PREVOST

WARRANTY BULLETIN

Wb09-17A

SUBJECT: INPECTION OF WELD BEADS ON 85" SUPER

FIGURE 1: INSPECTION

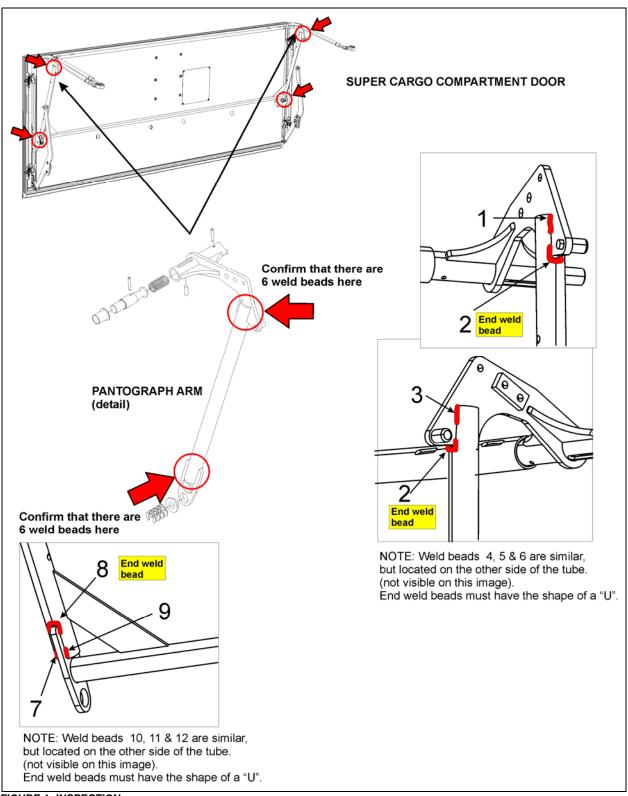
- Inspect as per figure 1. Make sure that the 24 weld beads are present on the pantograph arm (24 weld beads per door, 2 doors to be inspected). Furthermore, end weld beads (a total of 4) must have the shape of a « U ».
- If at least, one weld bead is missing, go directly to Part 2 for replacement of the pantograph arm. If the end weld beads do not form a « U », proceed to Part 2 for replacement of the pantograph arm assembly #288783.
- Following this inspection, if no weld beads are faulty, it is <u>not necessary</u> to replace the pantograph arm assembly #288783.
